South Texas Project Electric Generating Station P.O. Box 289 Wadsworth, Texas 77483

April 29, 2010  
U7-C-STP-NRC-100093

South Texas Project  
Units 3 and 4  
Docket Nos. 52-012 and 52-013  
Response to Request for Additional Information

Attachments 2 through 7 are revised or supplemental responses to NRC staff questions included in Request for Additional Information (RAI) letter numbers 289, 299 and 302 related to Combined License Application (COLA) Part 2, Tier 2, Sections 3.7 and 3.8. References 1, 2 and 3 provided the original response to the following RAI questions:

Figure 3H.6-11k: Comparison of Spectra at Foundation of Emergency Diesel Generator Fuel Storage Vault – Upper Bound Soil Properties, Vertical Direction

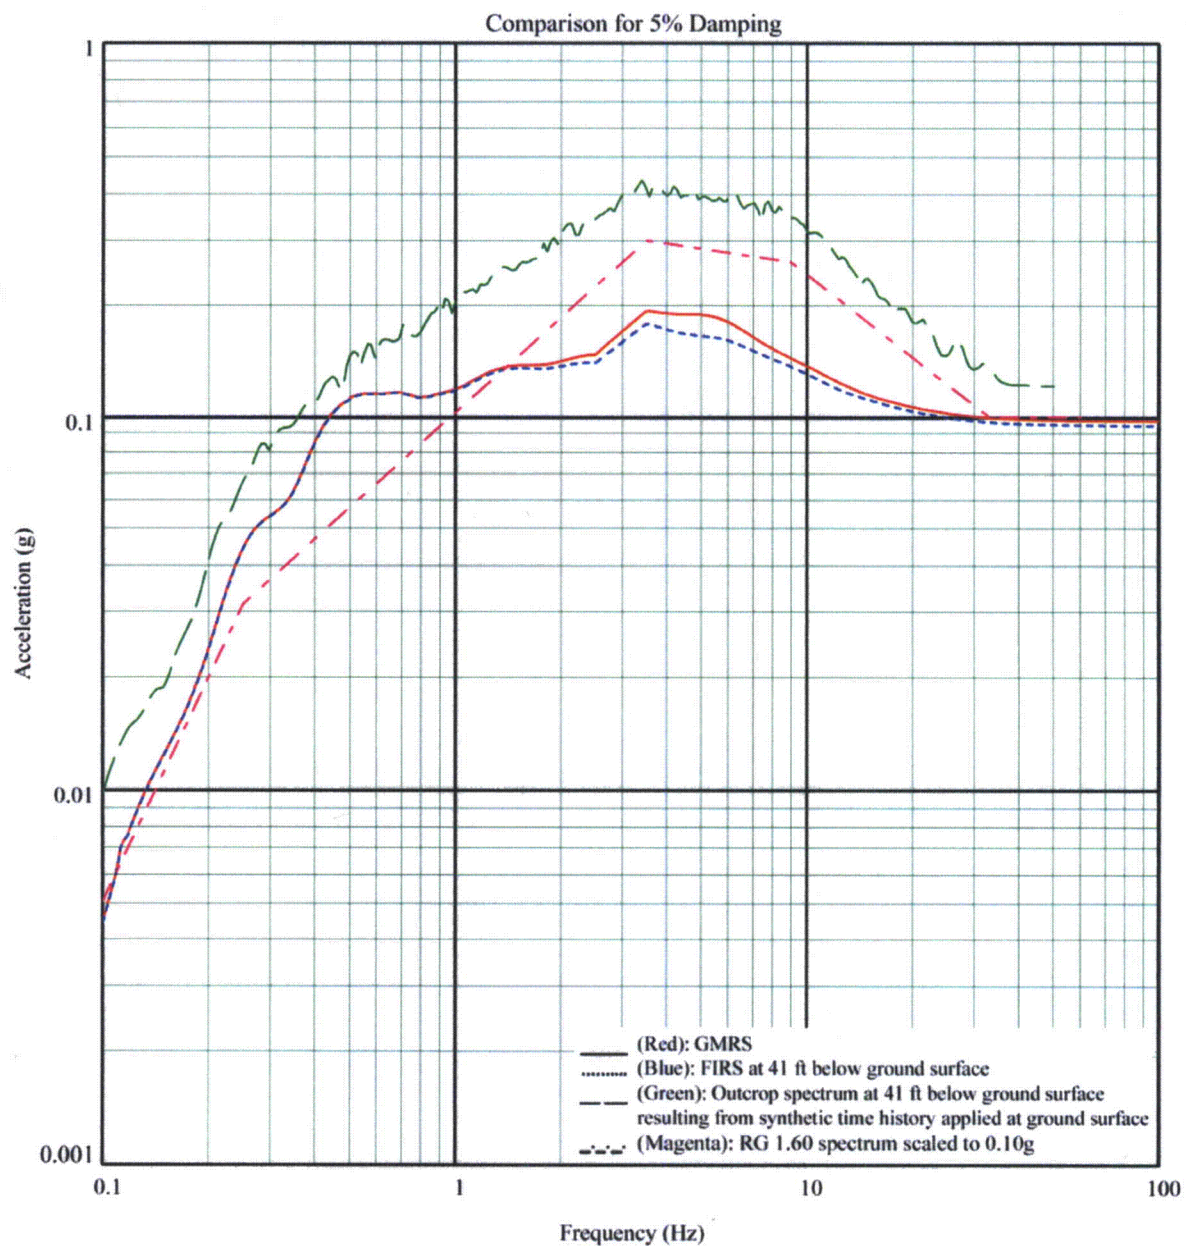
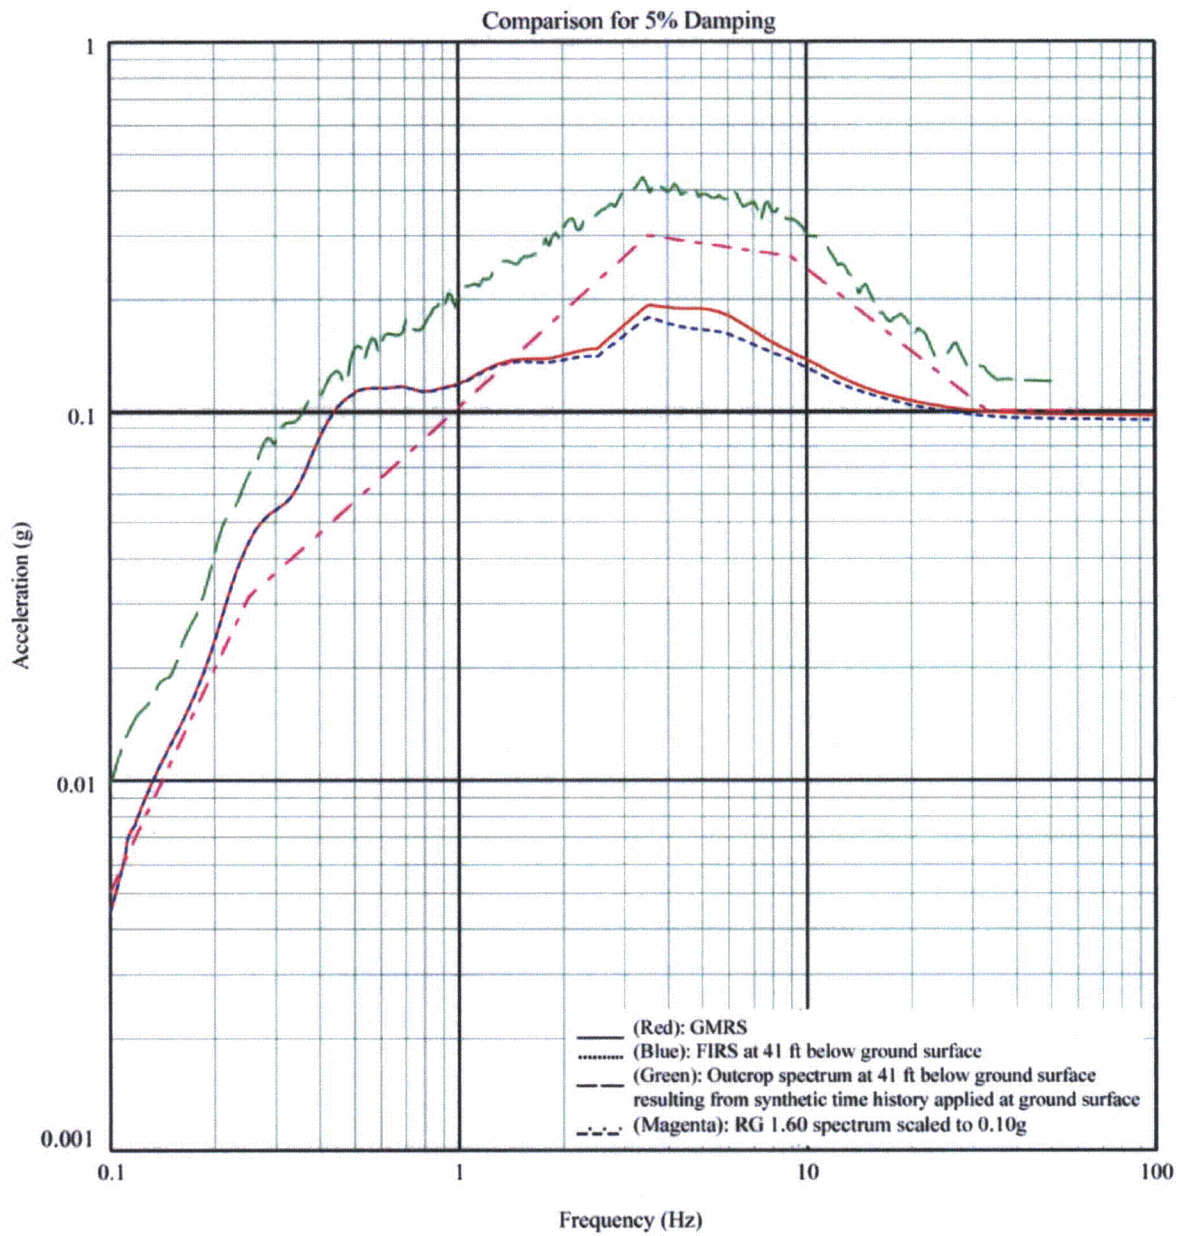
In response to RAI 03.07.01-6, the applicant referred to COLA Part 2, Tier 2, Section 3A.17 for description of the supporting media, dimensions of the structural foundation, and total structural height for the Reactor Building (RB) and Control Building (CB). However, the referenced section does not include the requested information for the Diesel Generator Fuel Oil Storage Vaults (DGFOVS) which is listed as Seismic Category I structure in Revision 3 of the FSAR Section 2.5S.4.10.2. As such, the applicant was requested to provide information on supporting media for DGFOVS. Since the shear wave velocity parameter of the subgrade material (soil or backfill) supporting this structure may be less than 1000 fps, the applicant is also requested to provide quantitative results of the reconciliatory site specific seismic analysis (with appropriate consideration of dynamic soil or backfill properties) addressing the potential impact on FIRS, SSI, settlement calculations, and structural design concerning DGFOVS.

3. In response to RAI 03.07.01-6, Item 3, the applicant states that, "The seismic site response analysis was conducted, as described in Section 2.5S.2.5, using P-SHAKE to develop Ground Motion Response Spectrum (GMRS). ...." No reference to P-SHAKE program was found in Section 2.5S.2.5 of Revision 3, and no proposed FSAR markup is provided for future incorporation. As such, the applicant is requested to clarify whether P-SHAKE program has been used to develop GMRS and strain-compatible soil properties, as described in Section 2.5S.2.5, and if so, how P-SHAKE program performs site-response analysis (e.g. deterministic or probabilistic method, etc.). The applicant is further requested to clarify whether P-SHAKE program was also used to perform deconvolution of the SSE design motion specified at the freefield ground surface to calculate the foundation motion for the Seismic Category I structures.

The comparison of response spectra (the minimum required 0.1g Regulatory Guide 1.60 spectra, the FIRS, and the deconvolved SHAKE outcrop spectra) at the foundation level of the DGFOVS is presented in Figures 3H.6-11d through 3H.6-11L, included in Enclosure 1. As can be seen from these figures, the deconvolved SHAKE outcrop spectra envelop the minimum required spectra and FIRS for the three sets of soil properties.

The comparison of response spectra (the minimum required 0.1g Regulatory Guide 1.60 spectra, the FIRS, and the deconvolved SHAKE outcrop spectra) at the foundation level of the DGFOVS is presented in Figures 3H.6-11d through 3H.6-11L. As can be seen from these figures, the deconvolved SHAKE outcrop spectra envelop the minimum required spectra and FIRS for the three sets of soil properties.

3. Add enclosed Figures 3H.6-11d through 3H.6-11L, and 3H.6-140 through 3H.6-208. Also, add Tables 3H.6-11 through 3H.6-13.

**Figure 3.7-40: Horizontal (N-S) Radwaste Building Mat Foundation Response Spectrum (7% Damping)**

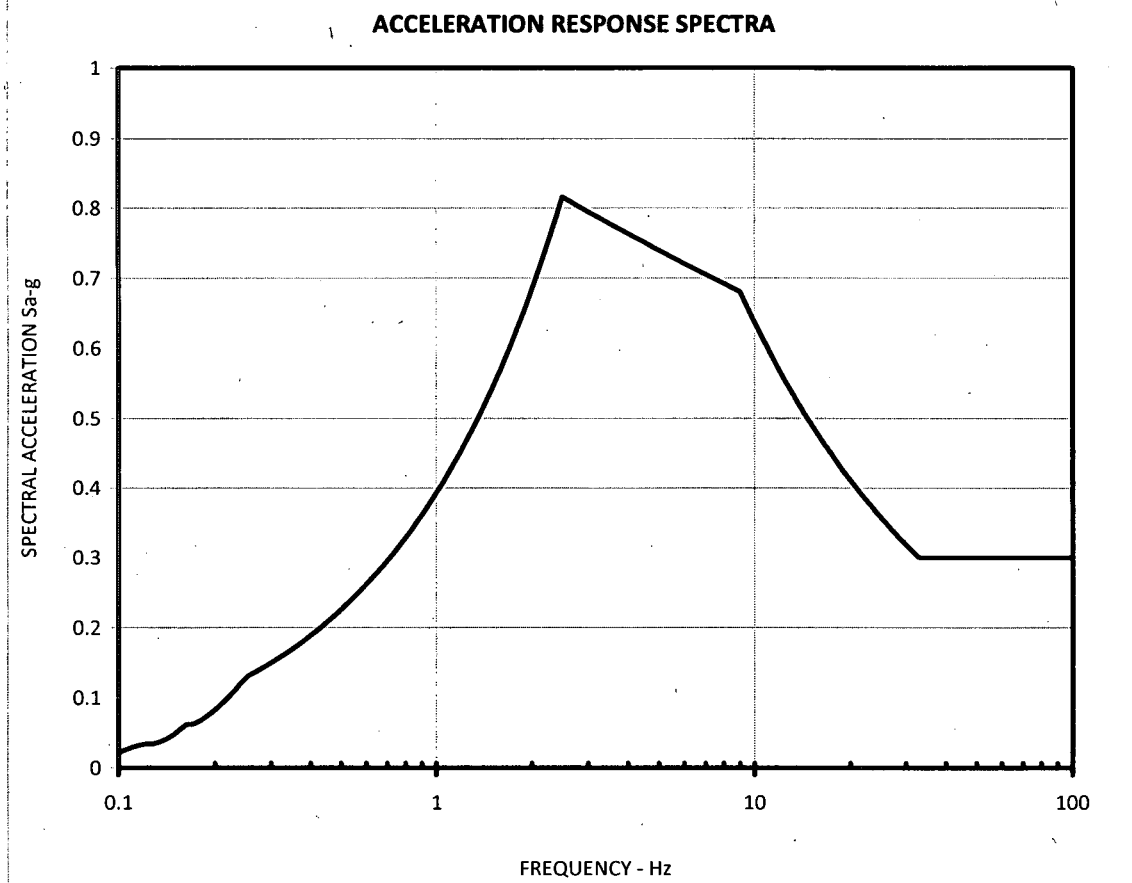
In the response to RAI 03.07.02-11, the applicant stated that, “***The analysis and design results will be available for review following the completion of the detailed design of the RWB currently scheduled for December 2010.***” Since this is part of the seismic SSI analysis and RWB is classified as a non-Category I structure with the potential to interact with Category I structures, the applicant is requested to provide the seismic input motion incorporating the effects of SSSI for design of the RWB. The applicant also is requested to include the method proposed in the response for establishing the design response spectra for RWB together with the design spectra input for RWB in the FSAR.

Attached Figures 3.7-40 through 3.7-42 provide the input motion at the foundation level for II/I design of the RWB. These input motions were developed in accordance with the method described in response to RAI 03.07.02-11.

For the Radwaste Building (RWB), the SSE input (see Figures 3.7-40 through 3.7-42) at the foundation level is the envelope of 0.3g RG 1.60 response spectrum and the induced acceleration response spectrum due to site-specific SSE that is determined from an SSI analysis which accounts for the impact of the nearby Reactor Building (RB). In this SSI analysis, five interaction nodes at the depth corresponding to the bottom elevation of the RWB foundation are added to the three dimensional SSI model of the RB. These five interaction nodes correspond to the four corners and the center of the RWB foundation. The average response of these five interaction nodes is enveloped with the 0.3g RG 1.60 spectra to determine the SSE input at the foundation level.

**Figure RAI 03.07.03-3A: Horizontal In-Structure Response Spectrum at Top of Control Building Mat (7% Damping)**

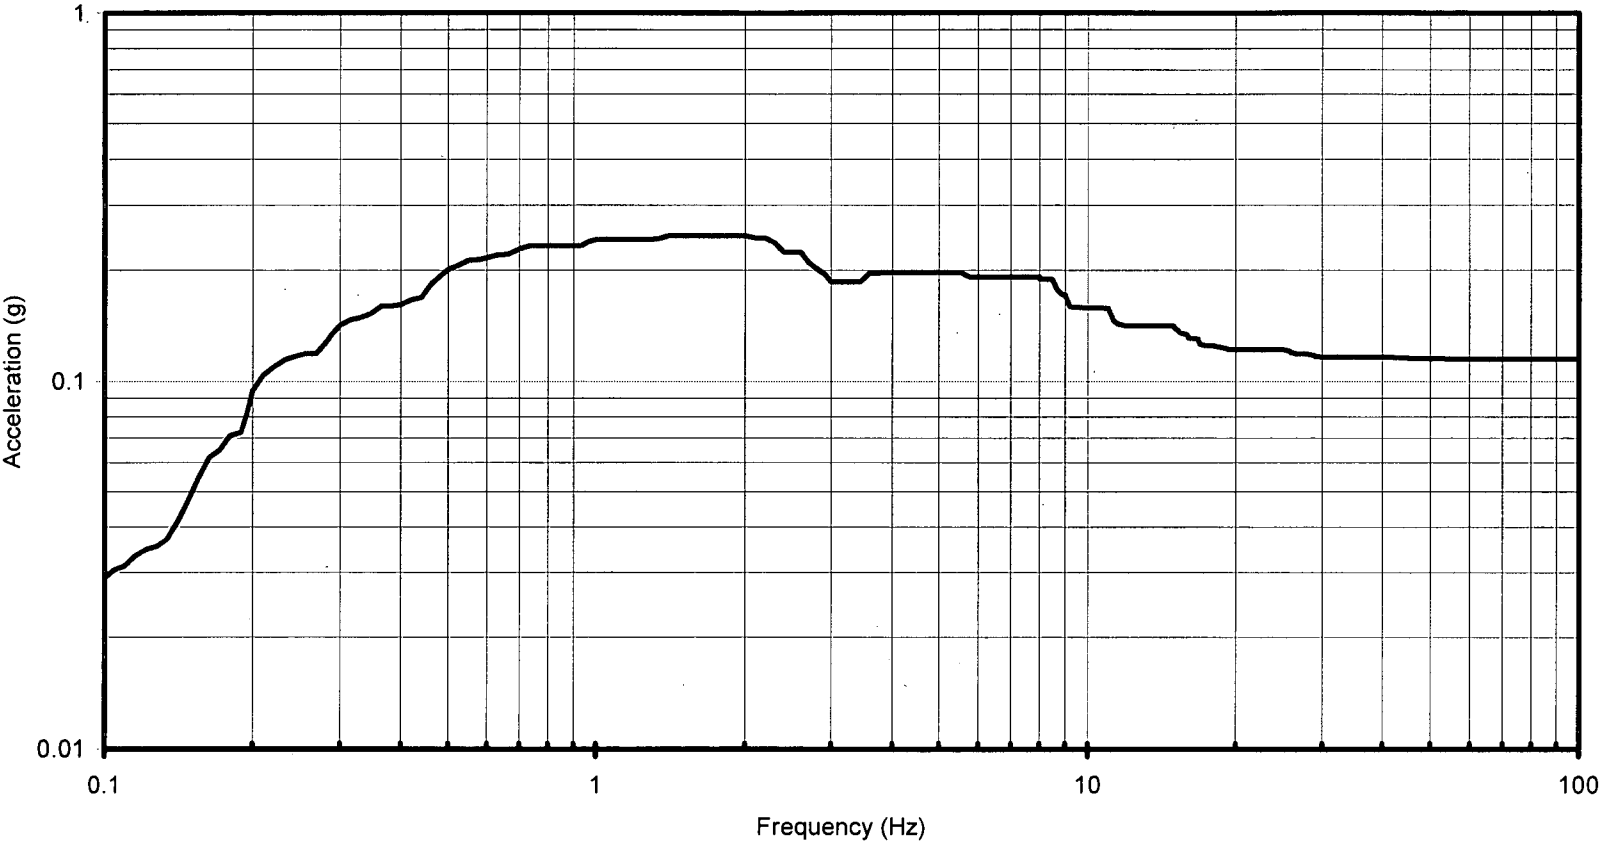
The applicant is requested to provide the results of the SSI analysis as described in the response together with the seismic input motion for the Control Building Annex in the FSAR. The results should include enveloped SSE input response spectra obtained for CBA foundation mat and In-Structure Response Spectra at CB foundation mat.

Attached Figures 3.7-38 and 3.7-39 are the resulting Safe Shutdown Earthquake (SSE) input spectra at the foundation level of the Control Building Annex for 7% damping. Seven percent damping spectrum is presented since it is consistent with the structural damping used for SSE. These input spectra were determined as described in response to RAI 03.07.03-1 (see letter U7-C-STP-NRC-090136, dated September 15, 2009, ML092610377). Attached Figures RAI 03.07.03-3A and RAI 03.07.03-3B are the corresponding site-specific in-structure response spectra at the top of the Control Building foundation mat.
